**MULTIPLE SEWERSHED  
PACKAGE 12-CIPP  
SAWS Solicitation No. CO- 00332  
SAWS Job No. 19-4544**

**ADDENDUM 2  
April 10, 2020**

**Multiple Sewershed Package 12 – CIPP  
Solicitation Number: CO-00332**

**N. PICOSO TO N. HAMILTON AVE. SHEET 1 OF 1**

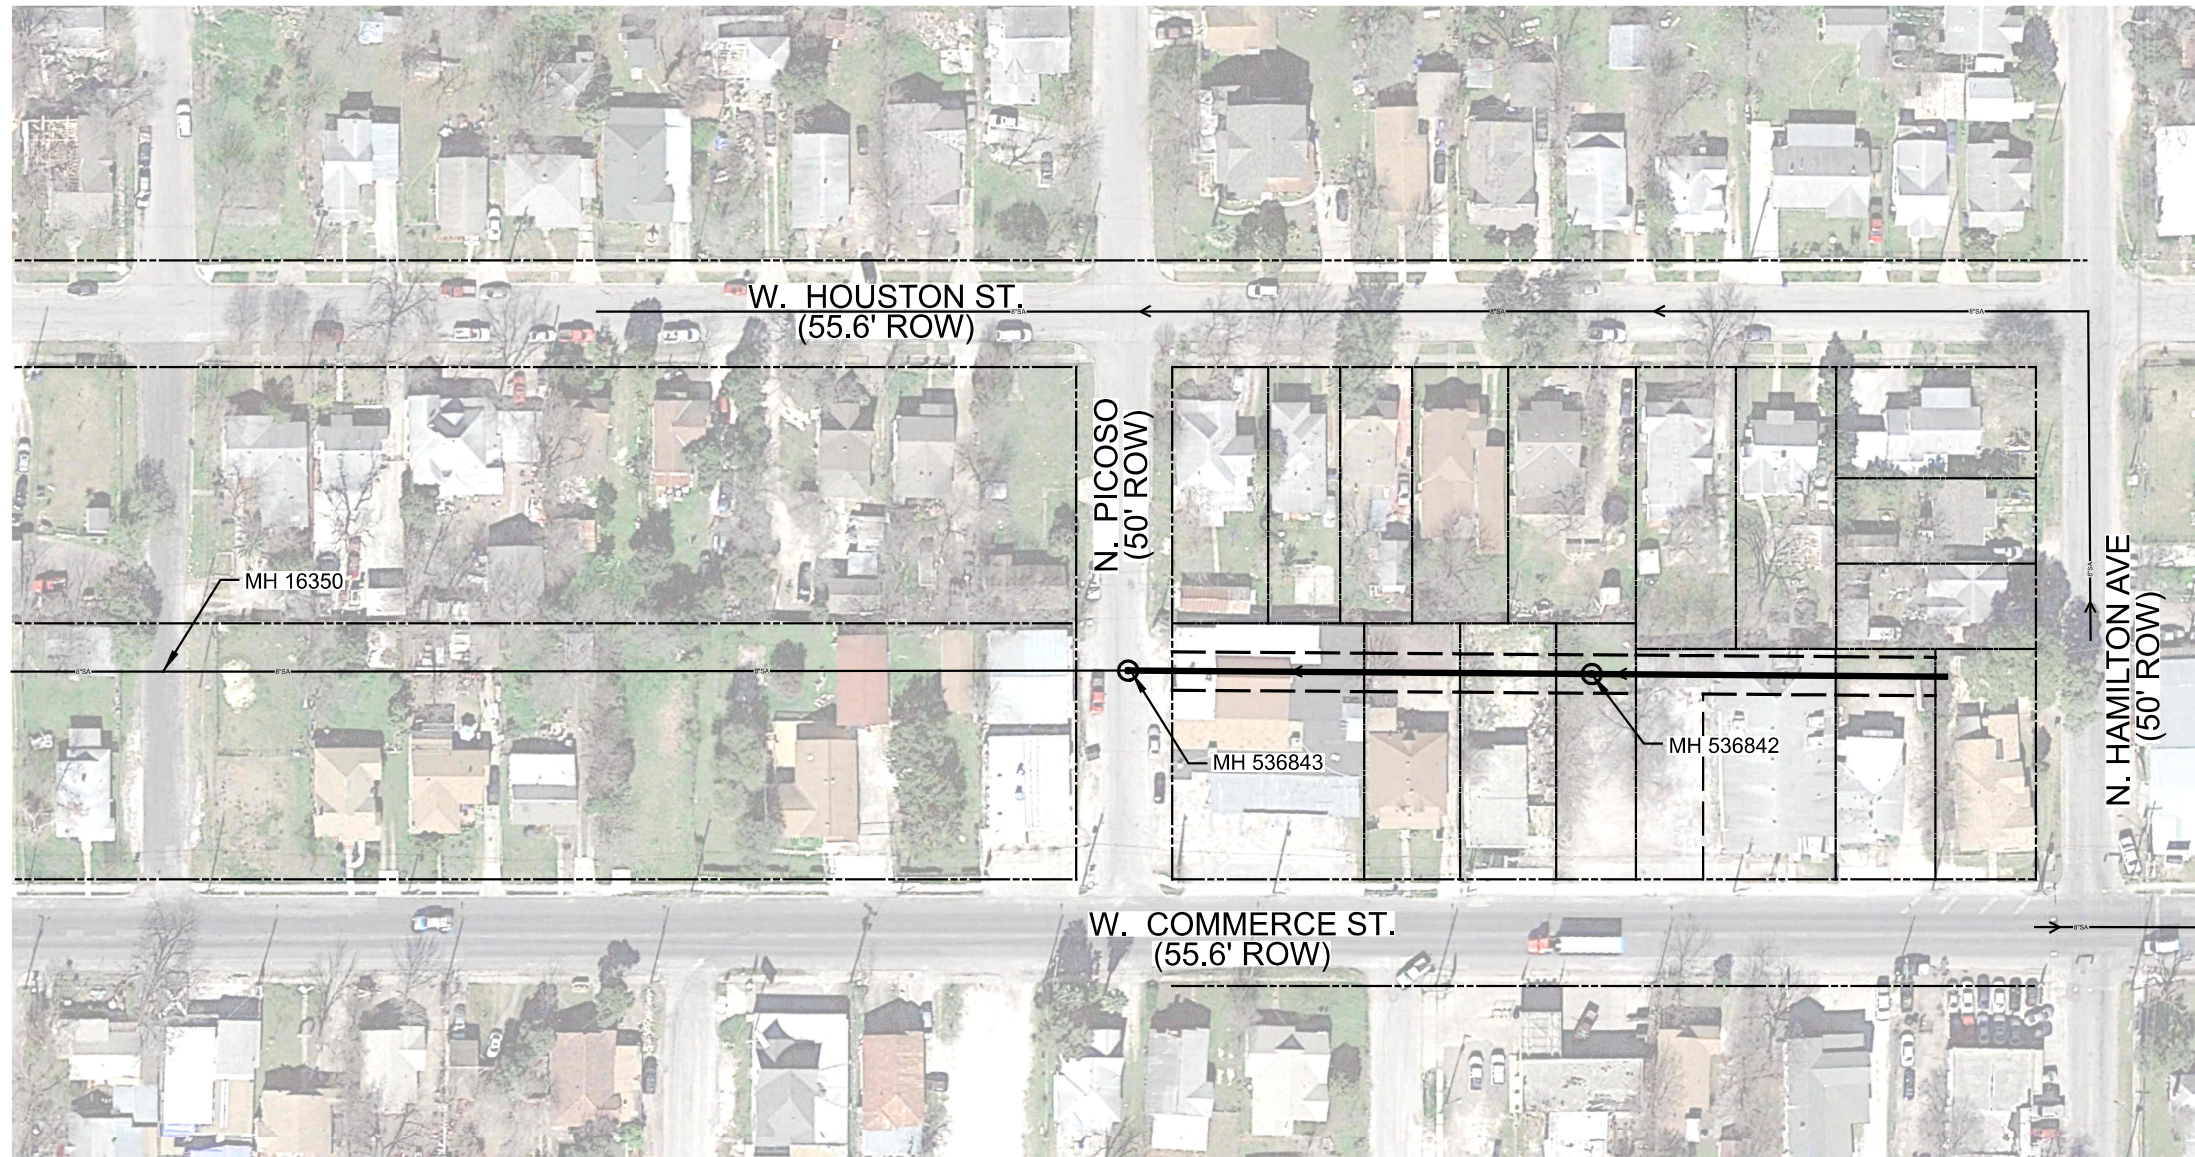
6. Question: **The Table of Estimated Quantities for the Picoso area on drawing sheet 19 calls for 5 CY of concrete encasement, cradles, saddles and collars, but this work does not appear to be noted or called out on the drawing itself. Please clarify how this concrete work will be used, and depending on what scope of work it is tied to, why it is not a pay item for any of the other areas.**

*Response: Quantities for Item 858, "Concrete Encasement, Cradles, Saddles and Collars" has been removed from quantity box on sheet 17. Revised sheet 17 is included in this addendum.*
